ADDENDUM NO. 2

**DARKE COUNTY BOARD OF COMMISSIONERS
Darke County Board of Developmental Disabilities
Administration & Community Services Renovation**

February 25, 2015

Re: Darke County Board of Developmental Disabilities
Administration & Community Services Renovation

RECEPTIONIST WINDOW DETAIL
SCALE: 1/2" = 1'-0"

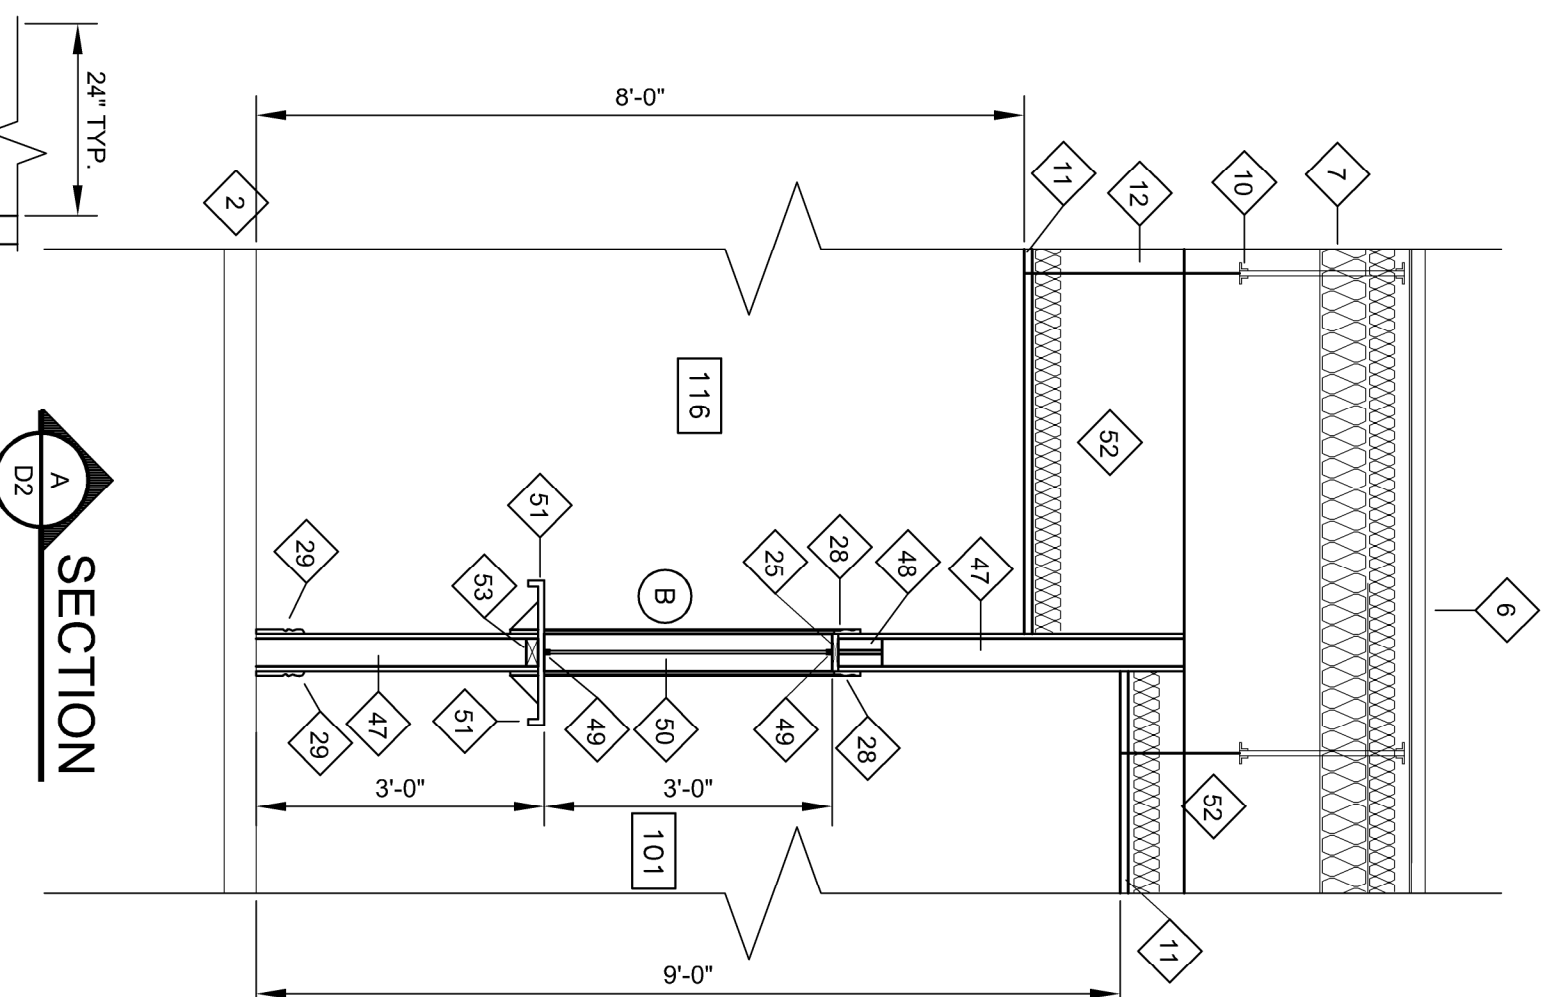
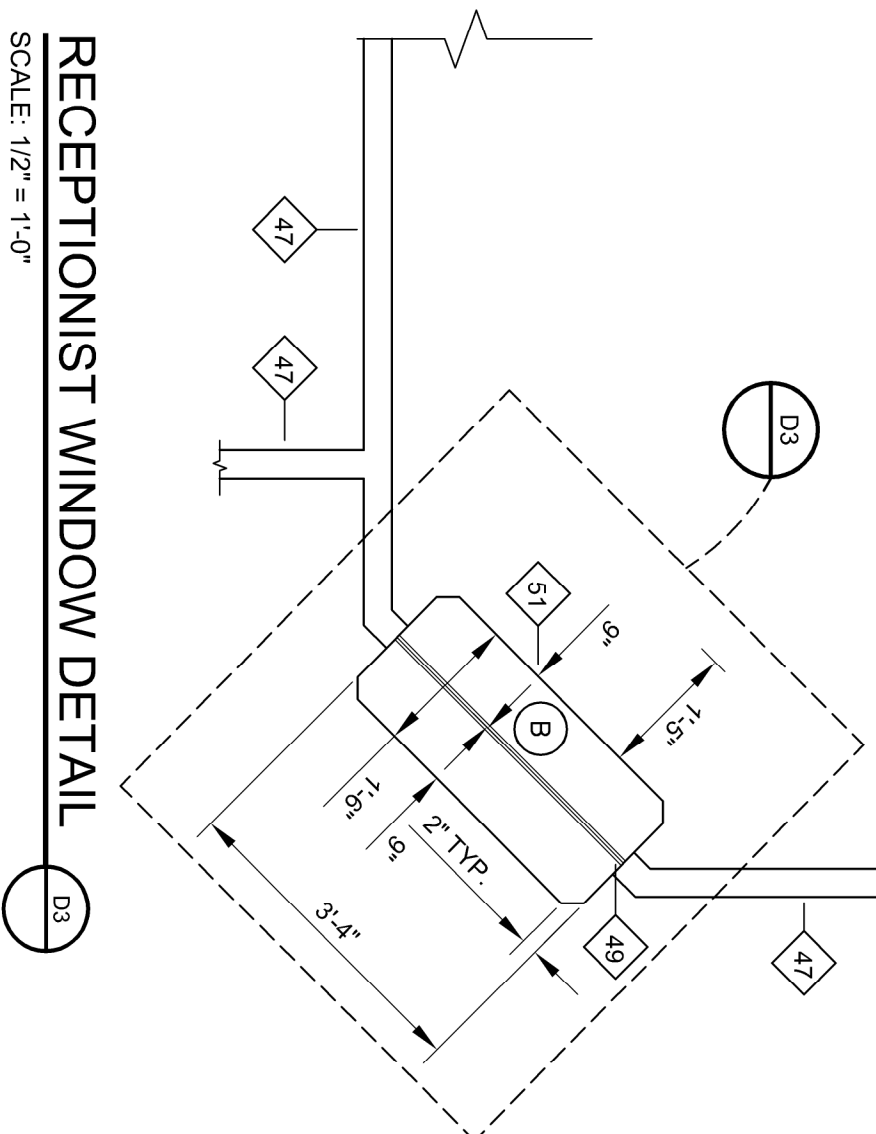
19. Sheet S5.01, DETAILS

- A. The receptionist window details on sheet S5.01 have been revised to show the window sill at 36” A.F.F. and the window is now 36” high. A new drawing number S5.03 has been added and attached to this addendum.
